Summary of Amendments to the Design Manual: Barrier Free Access 2008 (April 2017)

Amendments to the Design Manual: Barrier Free Access 2008

(April 2017)

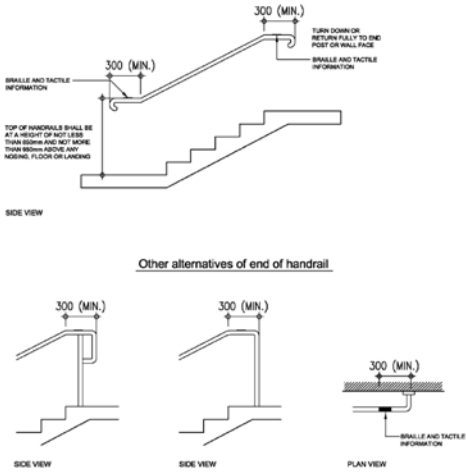
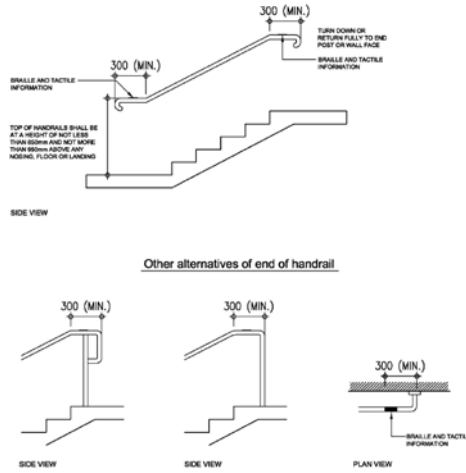
Item	2012 version	Amendments
<p>1. Figure 16A@</p>	 <p>Braille Characters (Cantonese and English)</p> <p>*ALL DIMENSIONS ARE IN mm</p> <p>Figure 16A – Handrails of Staircase</p>	 <p>Braille and Tactile Information (From Left to Right: Floor Number, Braille, Directional Arrow)</p> <p>Plan View</p> <p>*ALL DIMENSIONS ARE IN mm</p> <p>Figure 16A – Handrails of Staircase</p>

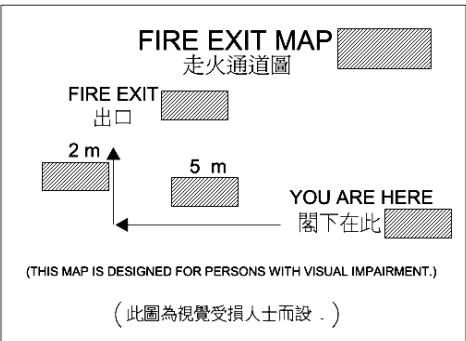
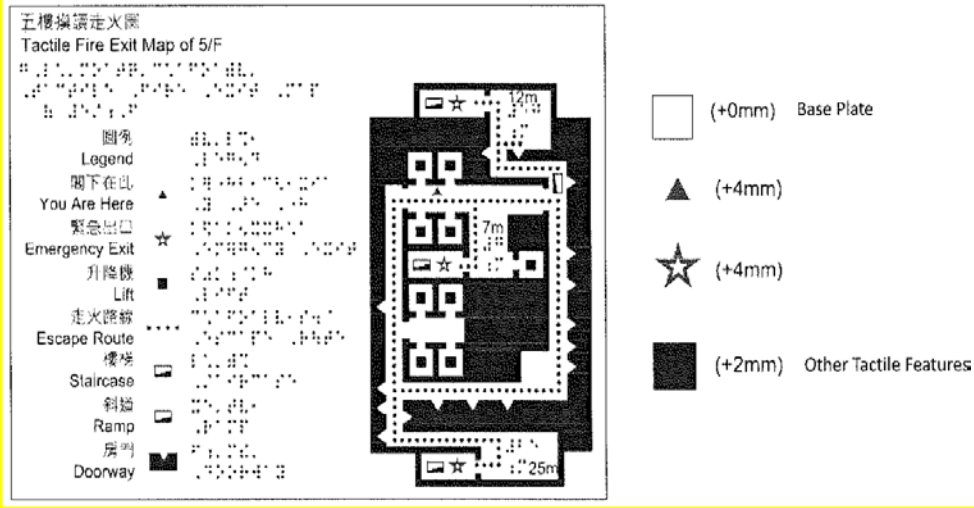
Item	2008 version	Amendments
2. Figure 32@	 <p>FIRE EXIT MAP 走火通道圖</p> <p>FIRE EXIT 出口</p> <p>2 m</p> <p>5 m</p> <p>YOU ARE HERE 閣下在此</p> <p>(THIS MAP IS DESIGNED FOR PERSONS WITH VISUAL IMPAIRMENT.) (此圖為視覺受損人士而設。)</p> <p>Note: → The 2m and 5m as shown on the Map are hypothetical figures only. They shall be subject to actual site condition.</p> <p>Braille information</p>	 <p>五樓消防走火圖 Tactile Fire Exit Map of 5/F</p> <p>圖例 Legend</p> <p>閣下在此 You Are Here</p> <p>緊急出口 Emergency Exit</p> <p>升降機 Lift</p> <p>走火路線 Escape Route</p> <p>樓梯 Staircase</p> <p>斜坡 Ramp</p> <p>房門 Doorway</p> <p>Base Plate (+0mm)</p> <p>(+4mm)</p> <p>(+4mm)</p> <p>(+2mm) Other Tactile Features</p>

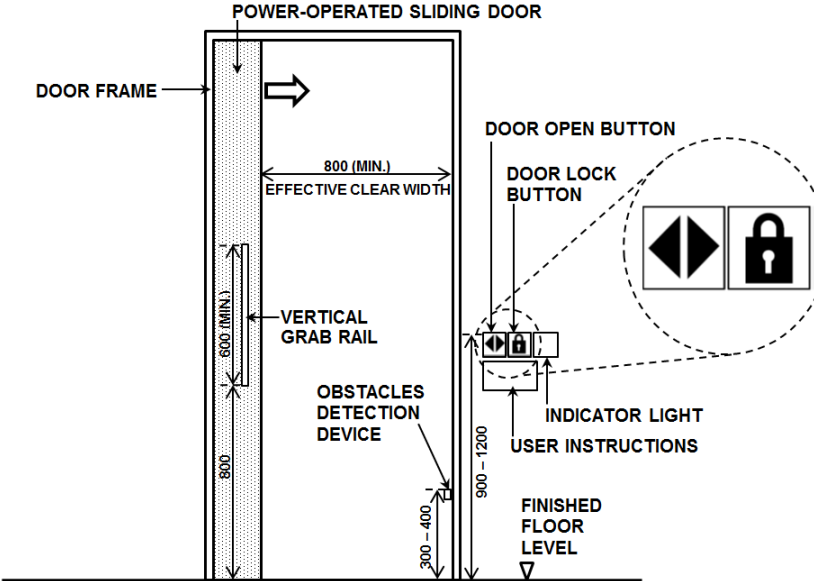
Item	2008 version	Amendments																											
4. Figure 31 in Division 13 of Chapter 4@	<div><table data-bbox="418 517 1061 592"><tr><td>Dot Spacing :</td><td>2.5 mm</td><td>Character Spacing :</td><td>6.5 mm</td></tr><tr><td>Dot Height :</td><td>0.5 mm</td><td>Line Spacing :</td><td>10.0 mm</td></tr><tr><td>Dot base diameter :</td><td>1.5 mm</td><td></td><td></td></tr></table><p data-bbox="427 619 759 639">Figure 31 – Specification of Braille Cells</p></div>	Dot Spacing :	2.5 mm	Character Spacing :	6.5 mm	Dot Height :	0.5 mm	Line Spacing :	10.0 mm	Dot base diameter :	1.5 mm			<div><div><p>(a) BRAILLE CELL</p><table data-bbox="1520 502 1807 655"><tr><td>Dot Spacing</td><td>:</td><td>2.5 mm</td></tr><tr><td>Dot Height</td><td>:</td><td>0.5 mm</td></tr><tr><td>Dot Base Diameter</td><td>:</td><td>1.5 mm</td></tr><tr><td>Character Spacing</td><td>:</td><td>6.5 mm</td></tr><tr><td>Line Spacing</td><td>:</td><td>10.0 mm</td></tr></table></div><div><p>(b) TACTILE SIGN</p><p data-bbox="1285 1179 1845 1200">Figure 31 – Specifications of Braille Cells and Tactile Signs</p></div></div>	Dot Spacing	:	2.5 mm	Dot Height	:	0.5 mm	Dot Base Diameter	:	1.5 mm	Character Spacing	:	6.5 mm	Line Spacing	:	10.0 mm

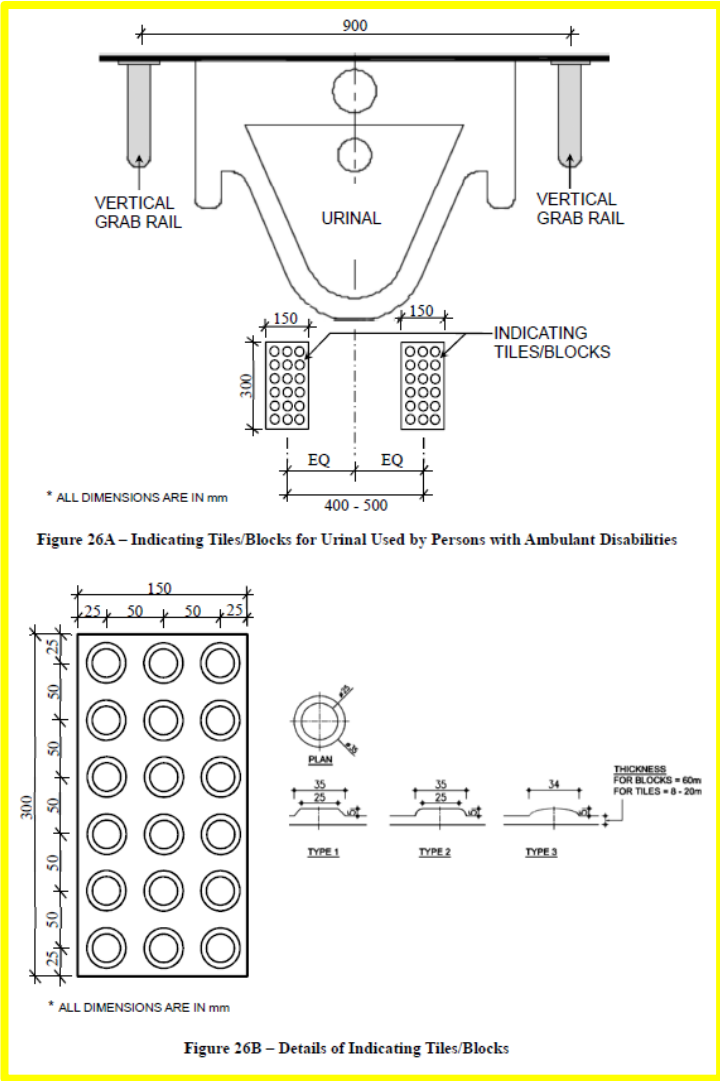
Item	2008 version	Amendments
7. Division 11 of Chapter 4*(cont'd)		<p data-bbox="1122 217 1388 248">(To add Figure 25A)</p> <div data-bbox="1122 280 2063 1222"> <p data-bbox="1189 1059 1518 1083">* ALL DIMENSIONS ARE IN mm</p> <p data-bbox="1189 1098 1883 1161">Figure 25A - Elevation of Power-operated Sliding Door (View from Outside of Accessible Toilet)</p> </div>

Item	2008 version	Amendments
7. Division 11 of Chapter 4*(cont'd)		<p data-bbox="1126 220 1391 252">(To add Figure 25B)</p> <div data-bbox="1149 284 2089 1034">  <p data-bbox="1193 930 1458 946">* ALL DIMENSIONS ARE IN mm</p> <p data-bbox="1189 962 1749 1010">Figure 25B – Elevation of Power-operated Sliding Door (View from Inside of Accessible Toilet)</p> </div>

Item	2008 version	Amendments
7. Division 11 of Chapter 4*(cont'd)		<p data-bbox="1126 217 1391 248">(To add Figure 25C)</p> <div data-bbox="1126 300 2101 1050">  <p data-bbox="1160 938 2072 965">Figure 25C – Plan of Power-operated Swing Door (Control Button(s) on Separate Walls)</p> </div>

Item	2008 version	Amendments
7. Division 11 of Chapter 4*(cont'd)		<p data-bbox="1126 217 1391 248">(To add Figure 25D)</p> <div data-bbox="1126 272 2101 879">  <p data-bbox="1189 799 2072 823">Figure 25D – Plan of Power-operated Swing Door (Control Button(s) on Same Wall)</p> </div>
8. Division 8 of Chapter 4*		<p data-bbox="1126 930 1843 962">(To add paragraph (e) after paragraph (d) in Section B)</p> <p data-bbox="1126 986 1312 1023">Slip-resistant</p> <p data-bbox="1126 1046 2116 1118">(e) The surface of the handrails provided under paragraph 28 in Division 8 should be slip-resistant, e.g. stainless steel with hair-line finish.</p>

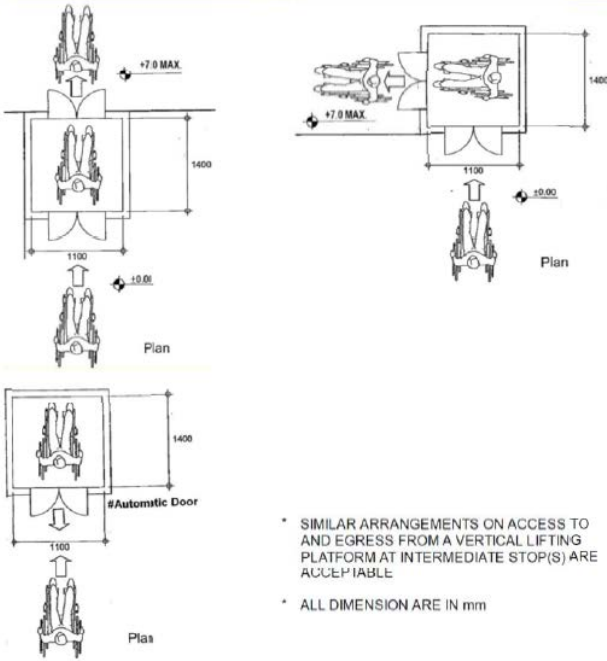
18.Division 11 of Chapter 4*		<p><i>(To add a heading and paragraphs (n) and (o) after paragraph (m) in Section B)</i></p> <p>Indicating Tiles/Blocks</p> <p>(n) Two indicating tiles/blocks on the floor to facilitate the use by persons with visual impairment (see Figures 26A and 26B) should be provided in front of the urinal for use by persons with ambulant disabilities.</p> <p>(o) The indicating tiles/blocks should have a minimum luminous contrast of 30% with the floor finishes.</p>

Item	2008 version	Amendments
19.Division 11 of Chapter 4*		<p data-bbox="1128 236 1518 272">(To add Figures 26A and 26B)</p> <div data-bbox="1263 296 1980 1382">  <p data-bbox="1301 786 1487 802">* ALL DIMENSIONS ARE IN mm</p> <p data-bbox="1294 828 1939 847">Figure 26A – Indicating Tiles/Blocks for Urinal Used by Persons with Ambulant Disabilities</p> <p data-bbox="1301 1299 1487 1315">* ALL DIMENSIONS ARE IN mm</p> <p data-bbox="1442 1340 1771 1359">Figure 26B – Details of Indicating Tiles/Blocks</p> </div>
